Mt. San Antonio College  
2018 Educational and Facilities Master Plan  
Draft Environmental Impact Report  
Response to Comments

SCH No. 2018091004

May 24, 2019

RE: Mt. San Antonio College 2018 Educational & Facilities Master Plan TIA & Draft EIR Peer Review  
19-0122

Figure 4A. Existing Traffic Volumes (Intersections 1-8, 22-28)

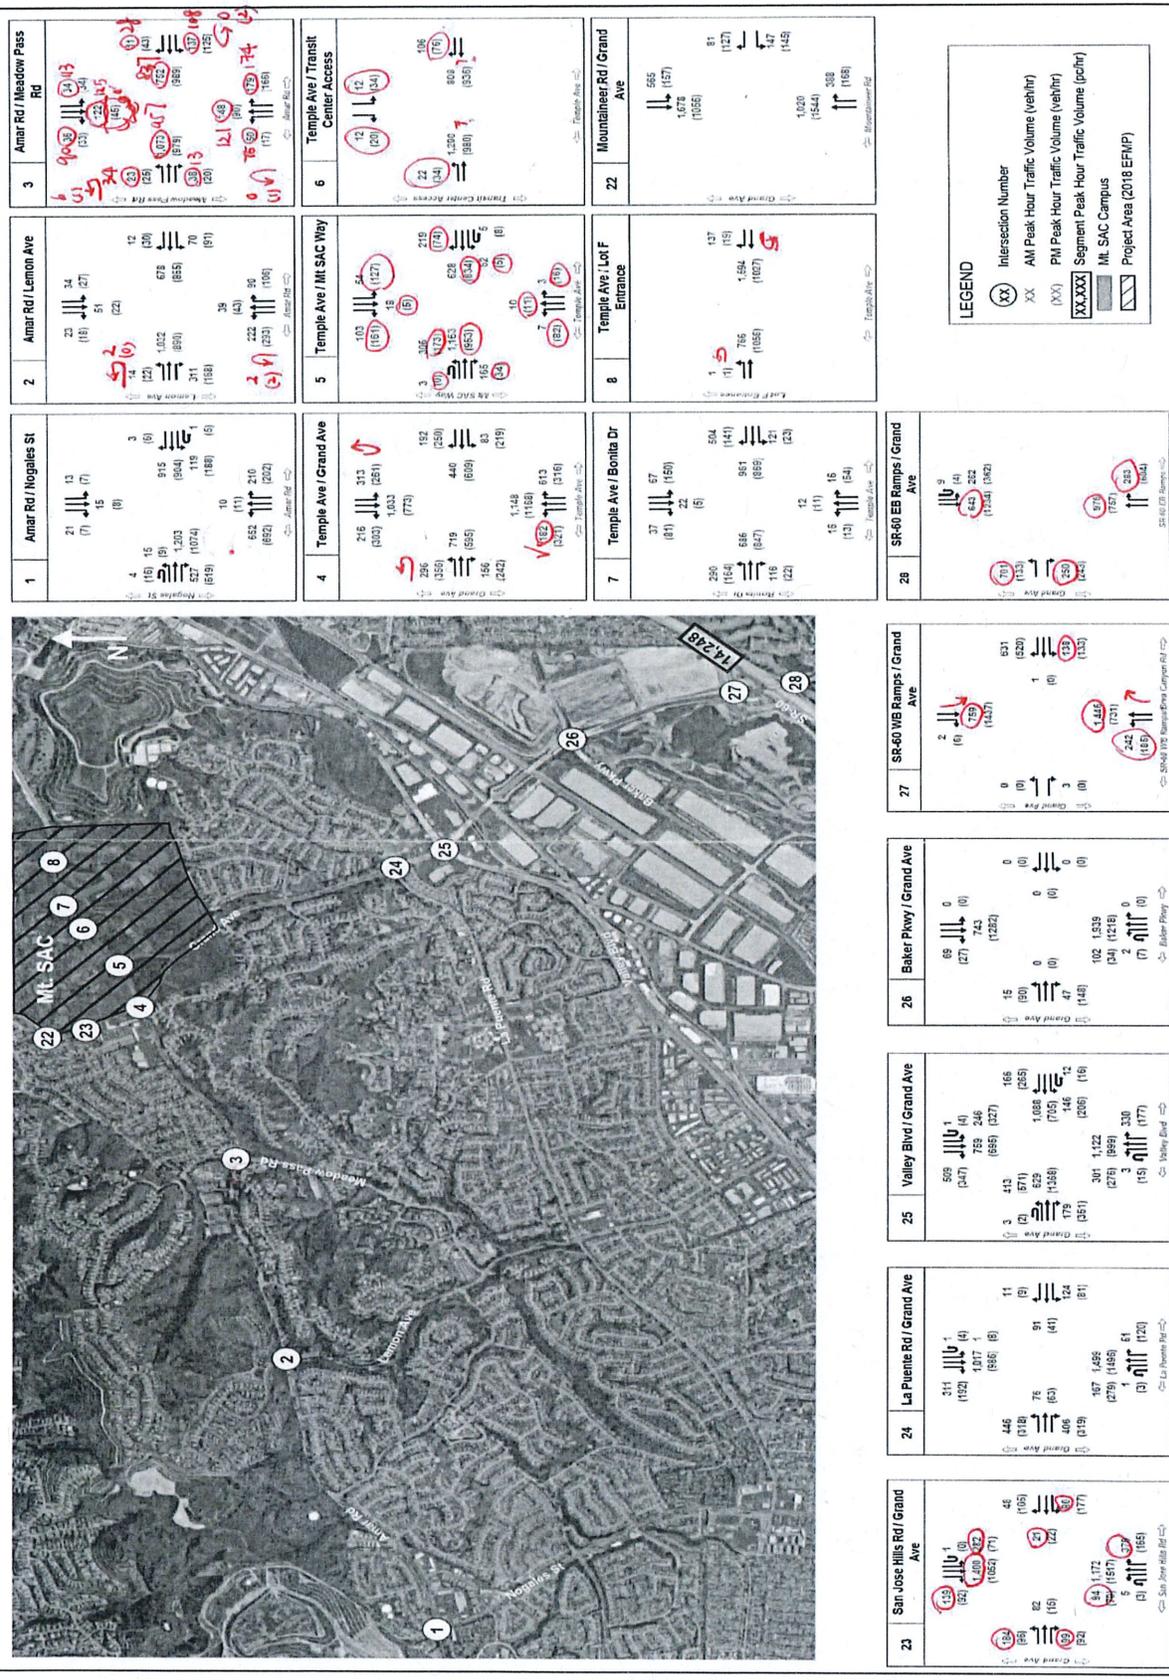
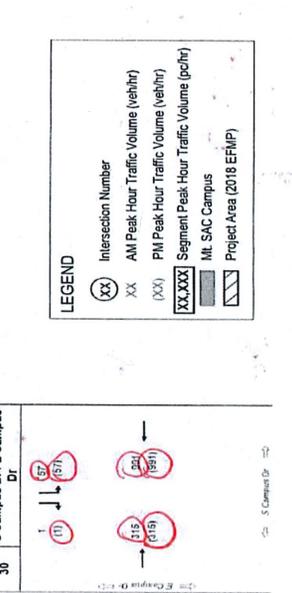
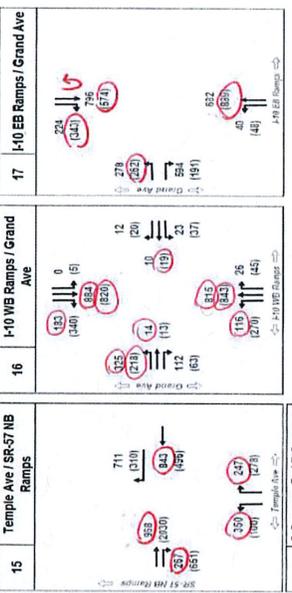
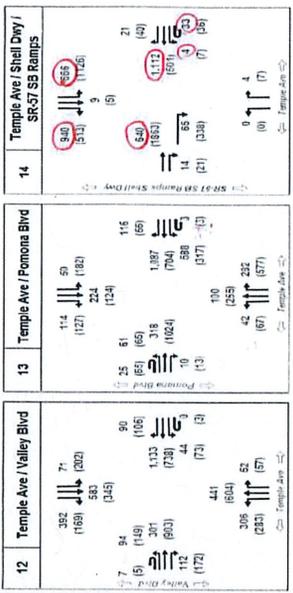
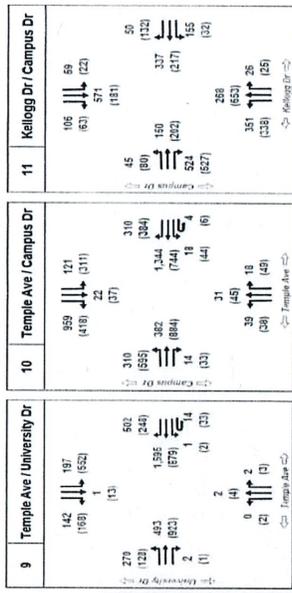
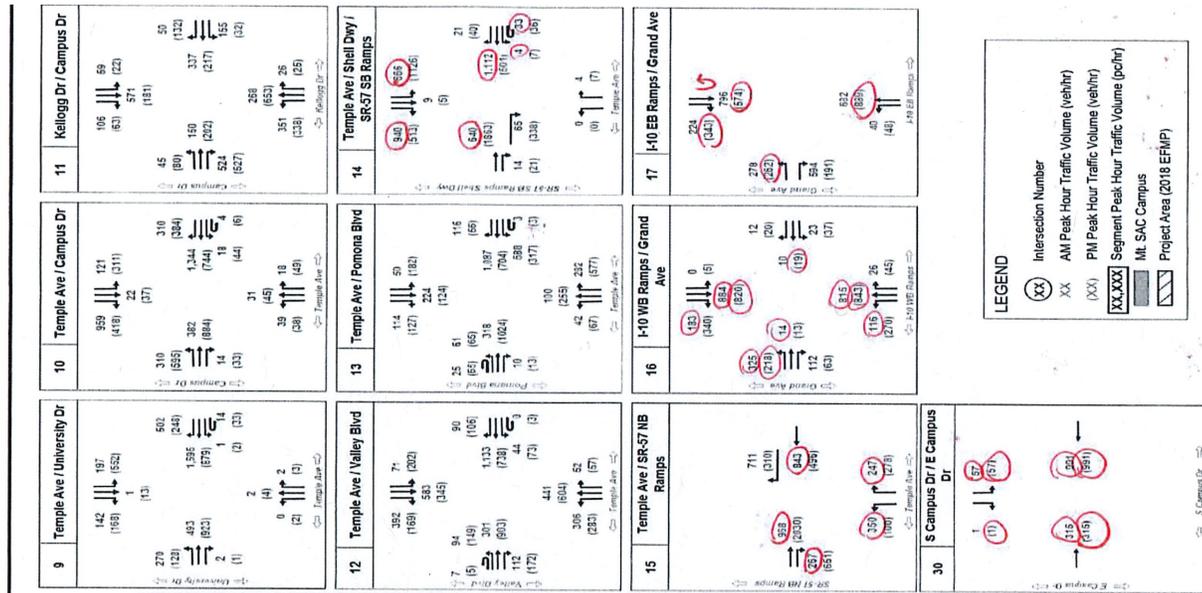
Figure 4A/B. Several of the existing intersection turning movement volumes are inconsistent with the count worksheets included in Appendix A of the 2018 EFMP TIA. These inconsistencies carry over to the Level of Service analysis and should be corrected as necessary. Attachment A of this peer review includes redlines of the intersection volumes that do not match the count worksheets.

As previously noted, Figure 4A/B – Existing Traffic Volumes is inconsistent with the existing count worksheets. The ICU/delay analysis volumes should be verified and revised as necessary.

20. The existing turning movement counts shown in Figure 4A/B are for the peak hours for the entire study area as opposed to the peak hours for each individual intersection. This

Exhibit 3-3 Campus Plan Use Plan, 2018 EIR

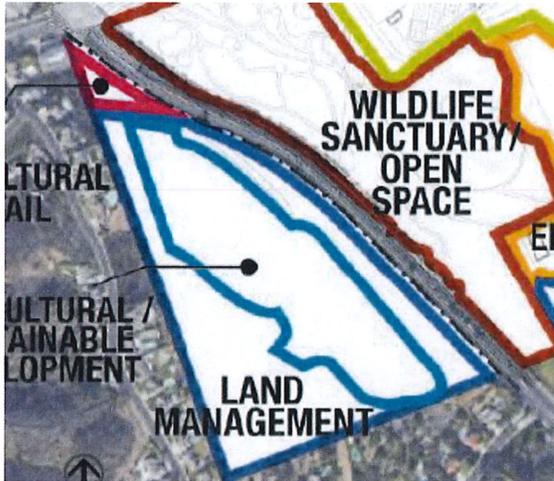
- 10) **Exhibit 3-3, after Page 3.5. Campus Land Use Plan.** Among other land uses, this Exhibit depicts an Agricultural/Sustainable Development zone at the West Parcel which is identical to the finished pad area of the latest West Parcel grading plan submitted by Mt SAC to the City of Walnut on July 2, 2018. EIR Section 1-3. Project Description, states "As shown, the proposed Mt. SAC Land Use Plan anticipates future development in six zones on campus: Primary Educational Zone, Athletics and Support Zone, Agricultural Zone, Wildlife Sanctuary/Open Space Zone, Land Management and Athletics Zone, and agricultural/Sustainable Development Zone. West Parcel development is further described in Section 1.3, Page 1.4, Project Description and Section 4.0, Introduction to Environmental Analysis of this Draft EIR." However, Exhibit, 3-3, Section 1.3 and Section 4.10 do not justify an Agricultural/Sustainable Development zone designation over the finished grading pad, for the following reasons:

- 11) The West Parcel development Agricultural/Sustainable Development zone pad area outlined in Exhibit 3-3, Campus Land Use Plan and Exhibit 3-4, 2018 Facilities Master Plan coincides identically with the outline of the finished graded pad of the latest Mt SAC grading permit submittal to the City of Walnut on July 8, 2018 (see Page 4, comparing Exhibit 3-3, Exhibit 3-4 and July 8, 2018 Grading Plan). This grading configuration is consistent with the placement of 140,000 cubic yards of earth fill at the West Parcel site and therefore is non-compliant with Section 2.a.i. of the Mutual Release and Settlement Agreement, which states, "Mt. SAC agrees it will not deposit approximately 140,000 cubic yards of earth on the "West Parcel" (as defined below) in connection with construction of the PEP."

11. Commenter states the “West Parcel development Agricultural/Sustainable Development zone pad area outlined in Exhibit 3-3 is consistent with the placement of 140,000 cubic yards of earth fill at the West Parcel site and therefore is non-compliant with Section 2.a.i. of the Mutual Release and Settlement Agreement, which states Mt. SAC agrees it will not deposit approximately 140,000 cubic yards of earth on the West Parcel . . . .” The comment is argumentative and does not raise or identify an environmental impact issue, but is noted and will be forwarded to the Mt. SAC Board of Trustees for review and consideration.

Exhibit 3-4 Facilities Master Plan, 2018 EIR

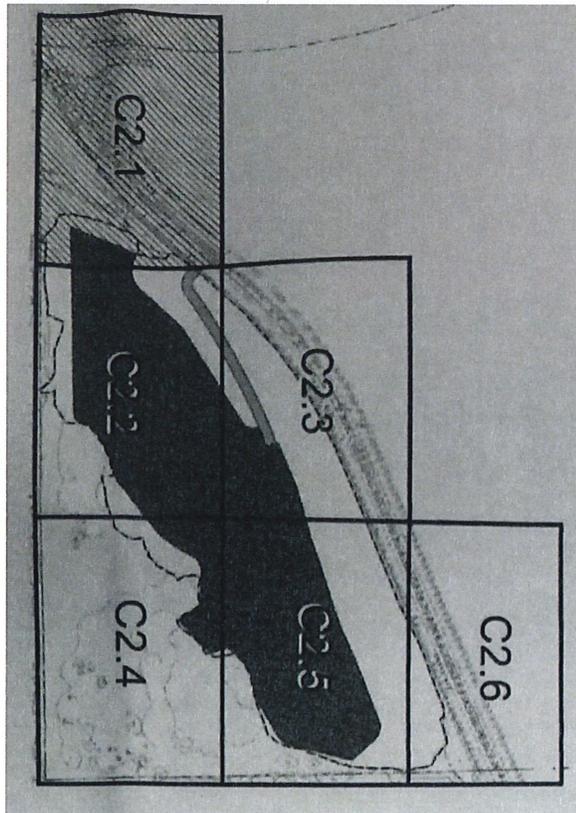
- 9) Several citations in the Mt. SAC 2018 Educational and Facilities Master Plan, Draft EIR, describe the grading plan of the West Parcel pad development. Among these are Exhibit 3-3, Campus Land Use Plan, Exhibit 3-4, 2018 Facilities Master Plan and Section 4.0 Introduction the Environmental Planning Process. These sections are cited below with accompanying comments in the context of the United Walnut Taxpayers/Mt SAC Mutual Release and Settlement Agreement, requiring that grading plans be withdrawn from the City's grading submittal process.
